CITY OF MOUNTAIN VIEW

STAFF REPORT

APRIL 19, 2017

5.1 Study Session to Discuss a Proposed Zoning Map Amendment and a Planned Community Permit to Construct Three, New 6-Story Office Buildings, Two, New 6-Level Parking Garages, and Retention of Three Existing Two-Story Office Buildings at 700 & 800 East Middlefield Road and 1100 West Maude Avenue

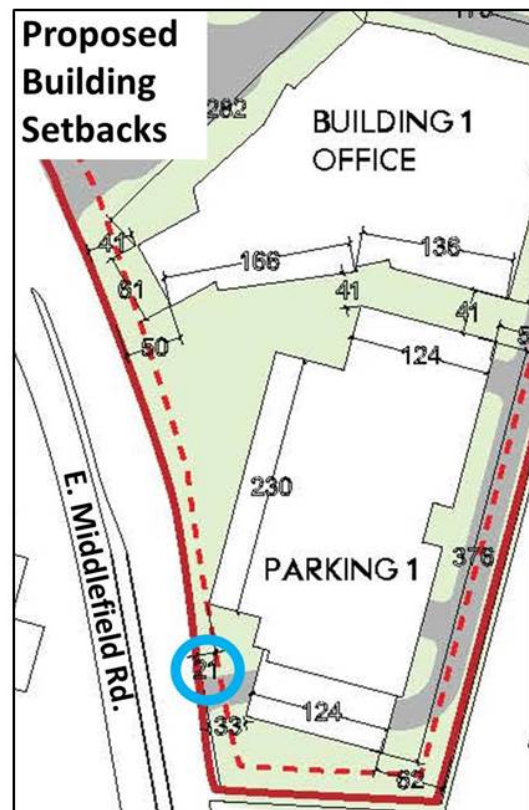
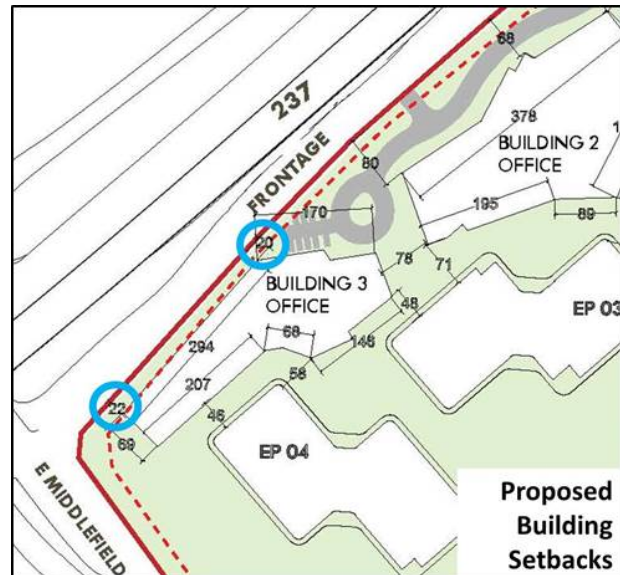
The existing office building setbacks from the adjacent public streets vary from approximately 150' to 200' to Maude Avenue and Middlefield Road, respectively. While staff supports locating buildings closer to the street to improve street

As part of the project development, the City will request new separated sidewalks and bike improvements along all three street frontages, which may require placing a portion of these improvements on the project site with public access easements. With these improvements, the building and parking structure may be less than 20' from the back of sidewalk along both street frontages. Staff would like the applicant to study alternative site designs that pull back the building and parking structures from the street, which may include reshaping the building/structure footprints and/or pulling Building 3 closer to adjacent buildings (while still meeting building and fire codes). If supported by EPC, city staff would work with the applicant to review alternative designs through the development review process, in coordination with the City's Development Review Committee (DRC).

QUESTION 3: Should the applicant consider alternative designs for Building 3 and Parking 1 to increase setbacks from the public streets?

Potential Pedestrian/Bicycle Circulation Improvements

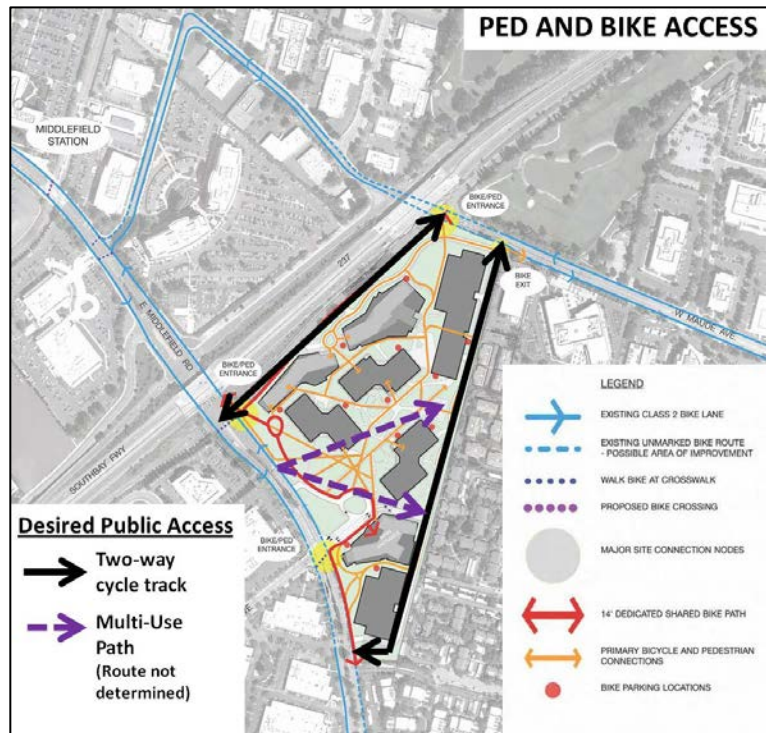
For this project, Planning and Public Works staff have identified key pedestrian and bicycle improvements on and adjacent to the project site, which would improve: (1) access to the site from the VTA light rail, (2) public circulation around the perimeter of the site, and (3) increase regional connections into Sunnyvale. These improvements include (see marked-up graphic on following page):

- **Cycle Tracks (shown in black)** – Provide buffered/separated two-way bicycle tracks connecting Middlefield Road and Maude Avenue along the project frontage at the SR-237 Frontage Road with a separated sidewalk, and along the east side of the new perimeter driveway aisle (with a public access easement);

- **On-Street Bike Lanes (shown in blue)** – Upgrade on-street bike lanes along the project frontage on Middlefield Road to a potential buffered on-street bike lane per the City's 2015 Bike Transportation Plan Update, with a new separated sidewalk; and include new on-street bike lanes and separated sidewalks along Maude Avenue consistent with the City of Sunnyvale's bike improvements; and
- **On-Site Multi-Use Path (shown in purple)** – Provide a multi-use public path(s) for pedestrian and bicyclists through the project site allowing connection from both Bernardo Avenue (which could connect with a planned undercrossing in Sunnyvale at Evelyn Avenue/Central Expressway), and the Middlefield Road/VTA station to Maude Avenue in Sunnyvale. The exact locations of the path(s) are not identified at this time, but would require public access easements.

QUESTION 5: Are staff-identified pedestrian-bicycle improvements for the project appropriate, or are alternative improvements/connections desired?
